Access Compliance Report

Public Rights-of-Way

(Curb Ramps)

Intersection ID: 13725	Main Street: AUBURNDALE_RD	Cross Street: N_SHARON_AMITY_RD	Location: W
ADA ID: 9DAF6F014AB0	Ramp Type: Perp	Initial Pass/Fail: Fail	Overall Compliance: No
Severity Score: 12.5			
Codes/Mitigation Info/Possible Solution		Field Measurements/Component Compliance

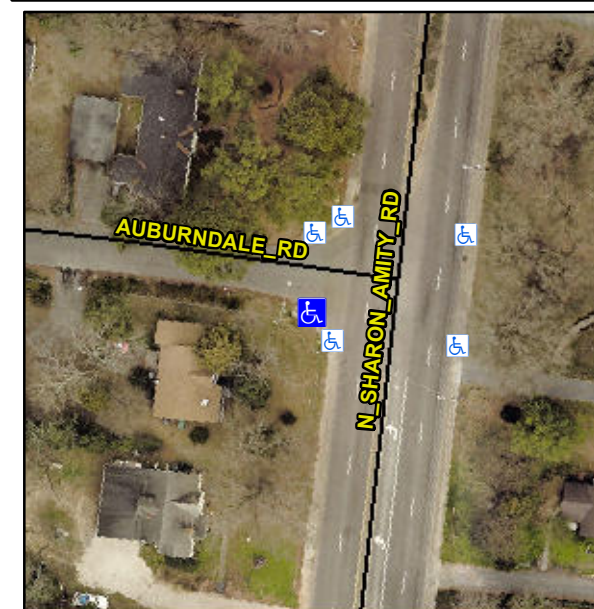
Not Found, R304.2.2

Compliance	Description	Data	Compliance	Description	Data
N/A	Ramp Length (in)	62.5	No	Ramp Slope (%)	10.8
Yes	Ramp Width (in)	48.0	Yes	Ramp XSlope (%)	1.3
N/A	Flare Type LT	N/A	N/A	Flare Type RT	N/A
N/A	Flare Slope LT (%)	N/A	N/A	Flare Slope RT (%)	N/A
N/A	Flare Traversable LT?	N/A	N/A	Flare Traversable RT?	N/A
N/A	Landing Length (in)	N/A	N/A	DWS Provided?	N/A
N/A	Landing Width (in)	N/A	N/A	DWS Contrast?	N/A
N/A	Landing Slope (%)	N/A	N/A	DWS Length (in)	N/A
N/A	Landing X Slope (%)	N/A	N/A	DWS Full Width?	N/A
N/A	Landing Curb? (Y/N)	N/A	N/A	DWS Offset (in)	N/A
N/A	Shared Landing?	N/A			
N/A	Gutter Ponding?	N/A	N/A	Gutter Slope (%)	N/A
N/A	Gutter Lip Ht (in)	N/A	N/A	Gutter X Slope (%)	N/A
N/A	Painted X Walk1?	No	N/A	Painted X Walk2?	N/A
	X Walk 1 Direction	To N		X Walk 2 Direction	N/A
N/A	X Walk 1 Width (in)	N/A	N/A	X Walk 2 Width (in)	N/A
	X Walk 1 Slope (%)	3.7		X Walk 2 Slope (%)	N/A
	X Walk 1 X Slope (%)	0.4		X Walk 2 X Slope (%)	N/A

Remove & Replace Entire Ramp.
